ISSUE: Permit to Demolish/Capsulate (partial) and Certificate of Appropriateness

APPLICANT: Properties Reimagined. LLC

400 N Fayette Street

Docket #9&10 BAR2024-00225 & BAR2024-00224 Parker-Gray District July 3, 2024

Photo 1: View of subject property from Princess St.

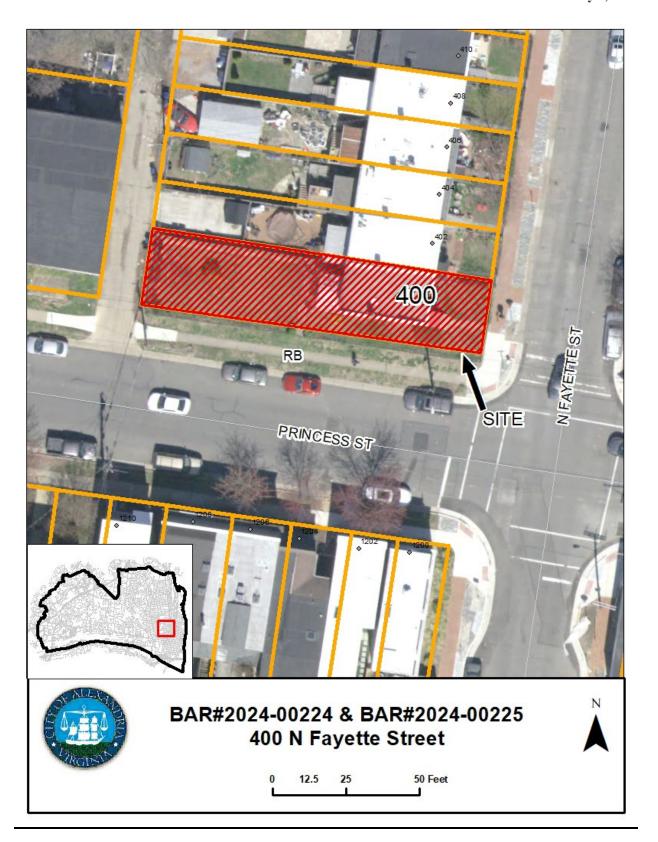
The applicant requests a Permit to Demolish/Capsulate (partial) and Certificate of Appropriateness to enclose two windows, demolish existing sunroom, extend the existing deck and convert a window into a door, as well as alterations, at 400 North Fayette Street.

Staff has no objection to the proposed alterations. The *Design Guidelines* state that windows and doors are character defining architectural features. The proposed reconfiguration of the existing windows and doors on the west elevation are architecturally appropriate and compatible with the

The *Design Guidelines* states that decks should not hide, obscure or cause the removal of historic architectural details. The proposed wood deck extension with 36" railing has a simple design that compliments the rowhouse. Decks constructed of unpainted pressure treated wood are discouraged in the historic district, so staff recommends the applicant paint or stain the deck to complement the predominant color of the building or trim.

Staff recommends approval of the Permit to Demolish/Capsulate (partial) and Certificate of Appropriateness for alterations, with the condition that the applicant paints or stains the deck to complement the predominant color of the building or trim.
